Countries: CANADA, UNITED STATES **Document ID:** IK1201215
Availability: ISIS, FleetSIS **Revision:** 0
Major System: ENGINES **Created:** 9/25/2014
Current Language: English **Last Modified:** 10/2/2014
Other Languages: NONE **Author:** Jeff Novak
Viewed: 224

Title: DTC 191-16 TOSS/VSS Service Information

Applies To: N13 OBD

Figure # 1: INCORRECT 191:16 Diagnostics

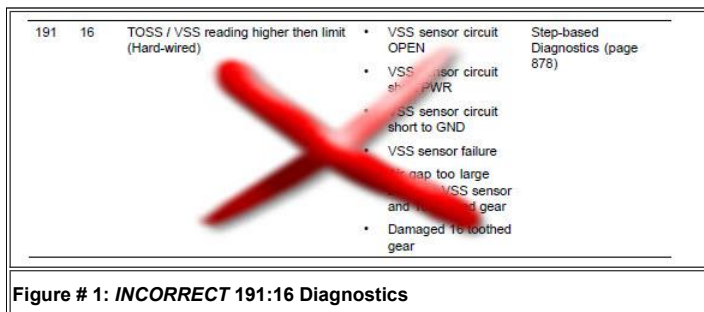
The diagnostics for fault code 191:16 have previously been to inspect the wiring, sensor and tone ring of the VSS. These diagnostics from the manual are *INCORRECT* and should not be followed when 191:16 is present (manual will be updated). This document explains how the 191:16 fault works and also covers setup of the vehicle over speed indicator.

This fault is not related to the vehicle speed sensor, wiring or tone ring, but a reaction to the "Vehicle Over Speed Indicator" programmable parameter(77542). If the customer has requested to turn on vehicle over speed notices to driver then the following parameters need to be programmed accordingly:

Once these parameters have been programmed accordingly and a the unit reaches a vehicle over speed the 191:16 fault will be logged in the ECM. Since the engine warning lamp(EWL) will be illuminated when the vehicle over speed occurs a fault must be stored in the ECM due to OBD requirements. The 191:16 fault is simply a result of a over speed being reached and should not be diagnosed as a hardware issue.
